Responses to s92 requests prepared by EGL in
respect of waste rock stack geotechnical matters

EGL Ref: 9642, 9745

Oceana Gold (New Zealand) Limited
Macraes Operation

**OCEANA GOLD (NEW ZEALAND) LIMITED
MACRAES OPERATION
MACRAES PHASE 4
WASTE ROCK STACKS - SECTION 92 RFI REPLY**

Figure A04

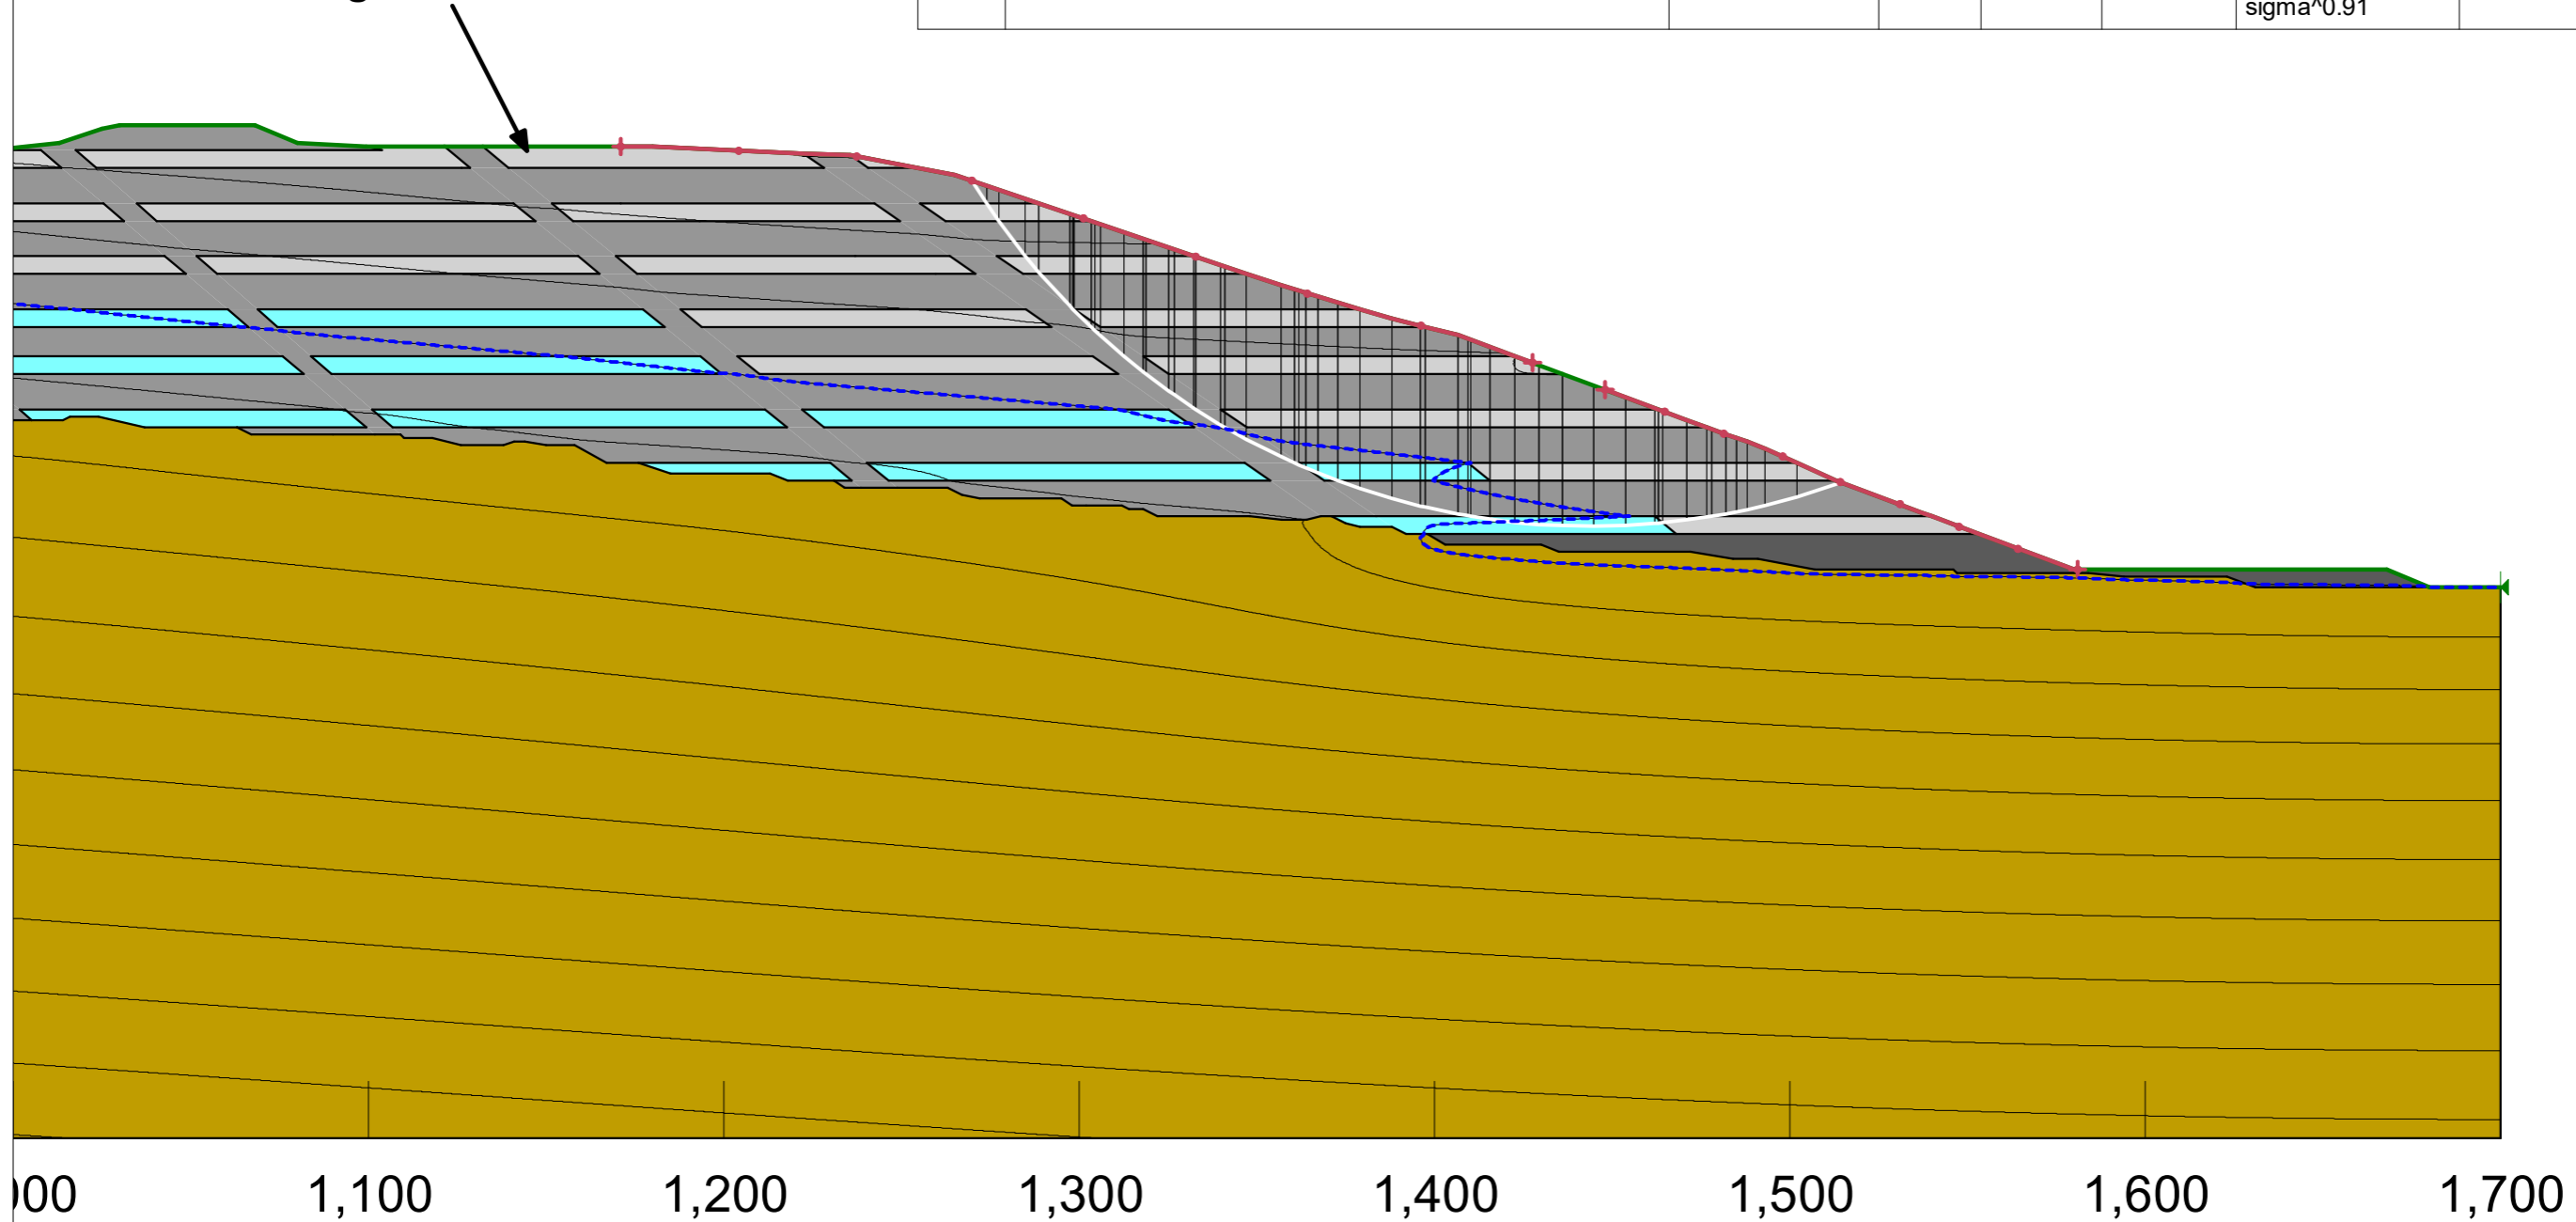
- 2.4 *The EGL (2024b) report mentions that the stratification results in contrasting strength within the WRS. The analysis only seems to use a stratified model on Figure A04, which is labelled as a post-earthquake scenario. Why is this stratified model not used for standard static and EQ analyses? Given the free draining rockfill, strength loss post-earthquake does not seem likely. Please explain.*

Pore pressure increase is unlikely to be notable under the static shear case or 150 year return period earthquake shaking case. The static strength parameter for waste rock when not softened (i.e. static and earthquake 150yr RP) already also allows for the finer fraction stratification. For the 2500 year earthquake we intend to run finer fraction softened strength. EGL will update the report to include this case. This will result in an increase in displacements. EGL has updated the Trimbells Waste Rock Stack – Closure Stability Report (Rev. 1 of the report, see Section 1).
